Lemanaghan Wind Farm

Stage 1 Road Safety Audit

Alan Lipsombe Traffic & Transport Consultants Ltd

March 2026

Figure 2.1 – The Existing Chevron Board Will Partially Obscure the Access Sight Lines

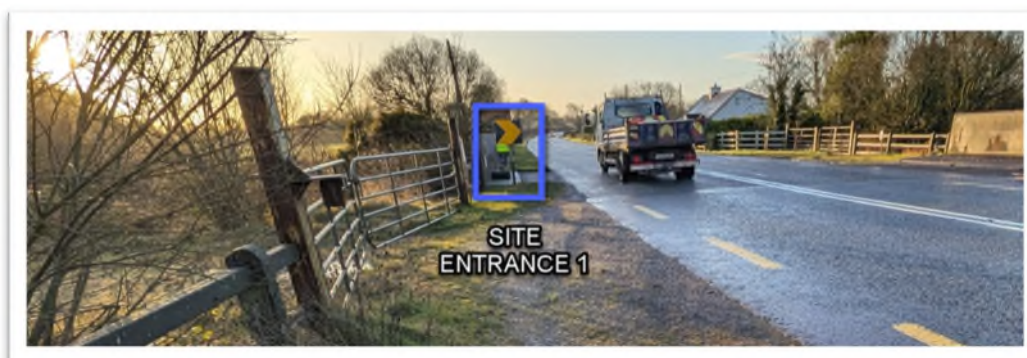
2.1 Problem: Road Sign Partially Obscuring Visibility

Location: Site Entrance 1 | Existing Chevron Board to South of Site Entrance 1

The line of sight looking to the left for drivers attempting to exit the access appeared to be partially obscured by an existing chevron board. This could increase the risk of side impact type collisions at the access.

The chevron board should be relocated to a suitable position which does not obscure visibility.

2.1	Yes	Yes	The relocation of the chevron board will be agreed with TII and Offaly County Council prior to finalising the detailed design of the proposed junction.	Comment noted
